**ON SITE SEWAGE DISPOSAL PLAN**

**SUIT PROPERTY**

12785 FREDERICK ROAD  
 TAX MAP: 15 \* BLOCK: 11 \* PARCEL: 71  
 3rd ELECTION DISTRICT \* HOWARD COUNTY, MD

**From:** Silvast, Zackary  
**Sent:** Tuesday, August 30, 2022 1:45 PM  
**To:** Linda D. Alexander  
**Cc:** Bernard, Dana; Margaret Suit; Todd Swanson  
**Subject:** RE: Suit Property...(clsi2021191) 12785 Frederick Road OSDS Plan review status

**PLAN**  
SCALE: 1"=30'

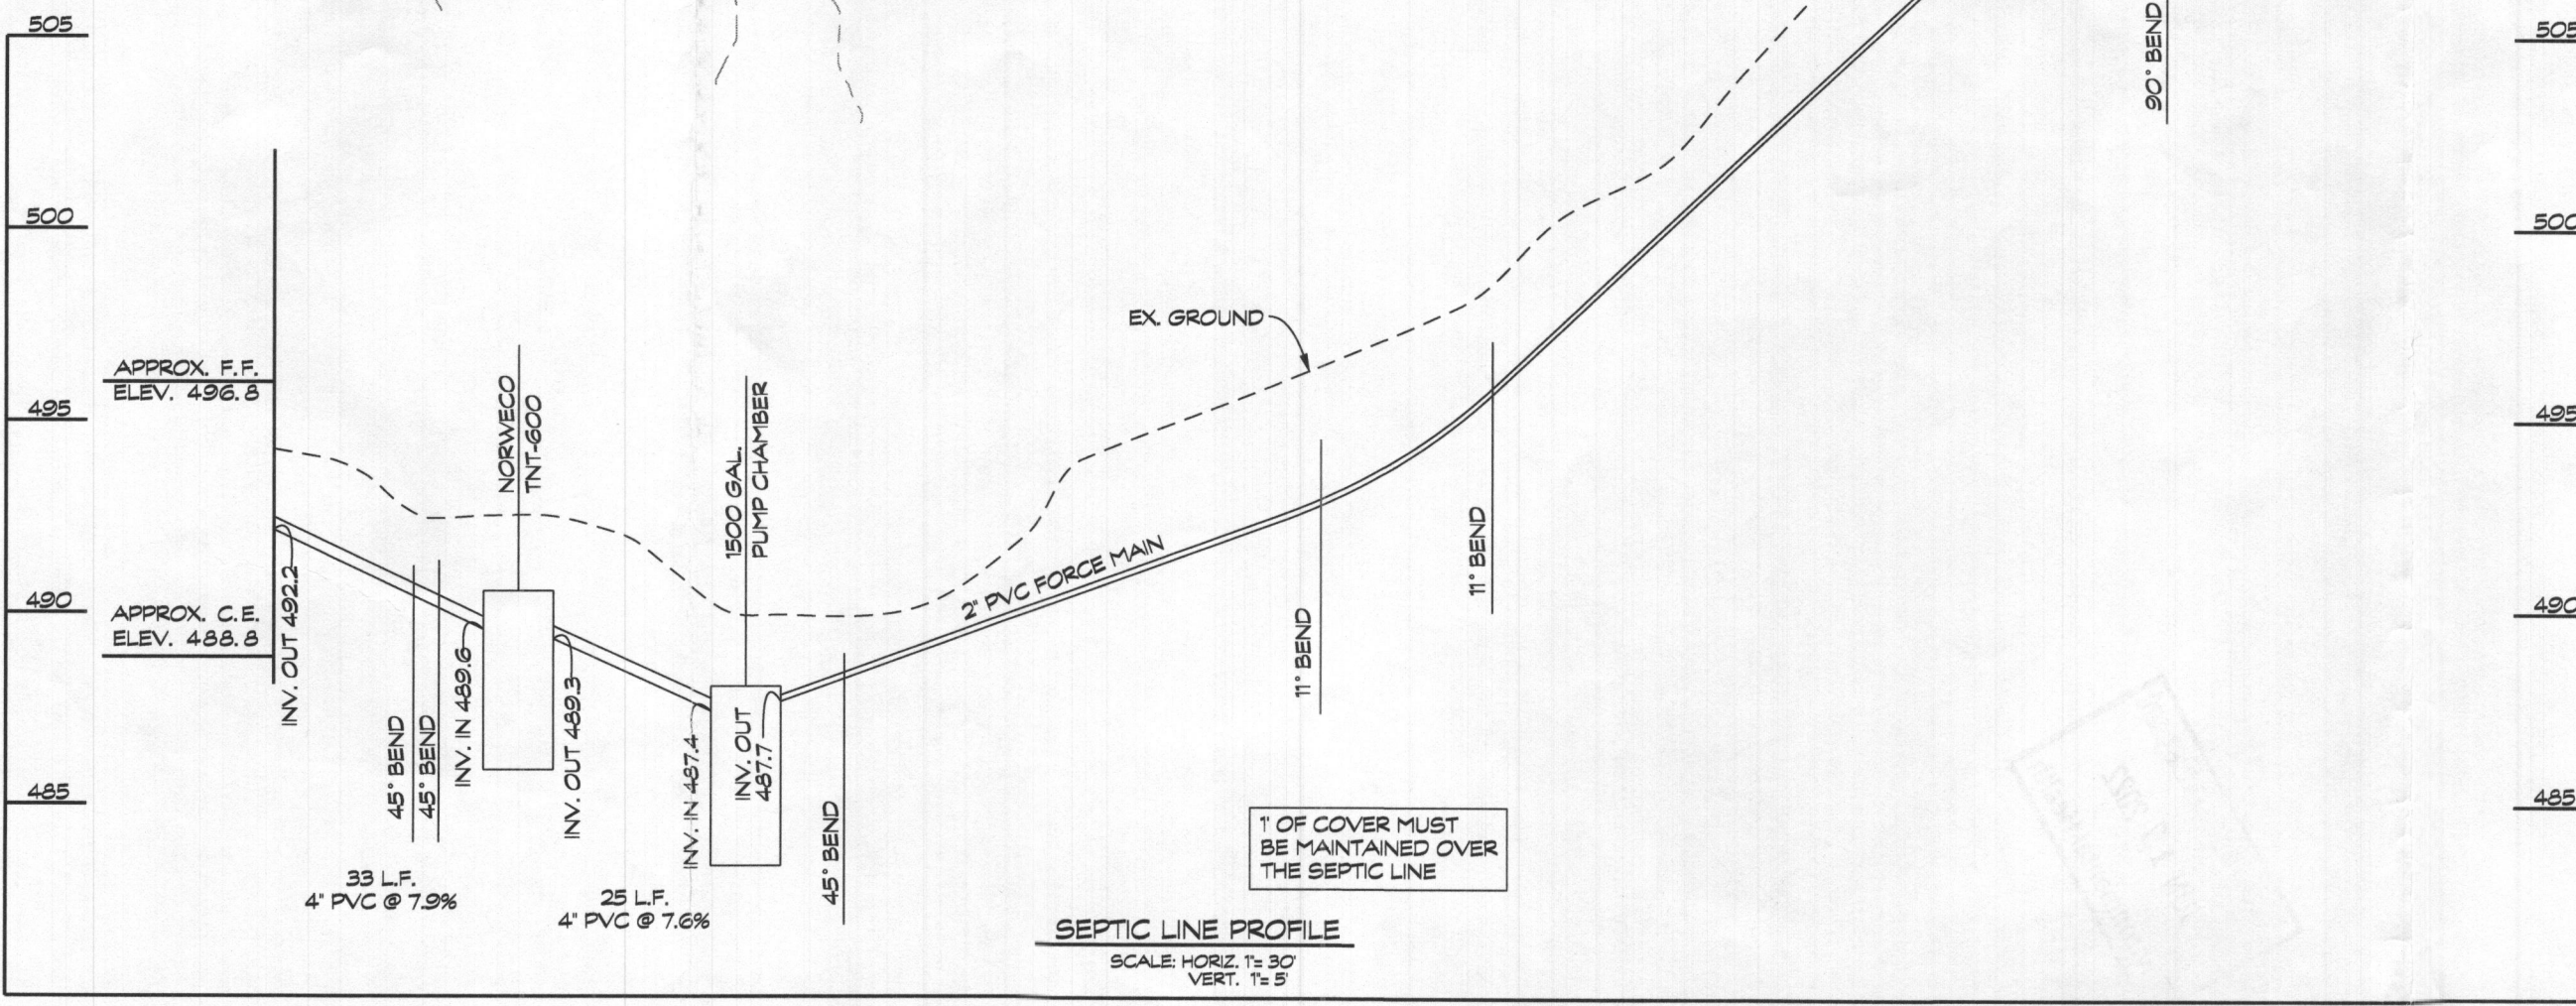
3. Force main should be clearly labeled.
4. The water line connection to the house should be shown.
5. The septic force main will need a 4" sched. 40 PVC sleeve where 10' separation cannot be maintained from any water lines.  
This section(s) should be clearly labeled on the site plan.
6. Need well tag number on OSDS plan.

8. Label dbox as "10-hole dbox"
  - a. Dbox should align with start of first trench.
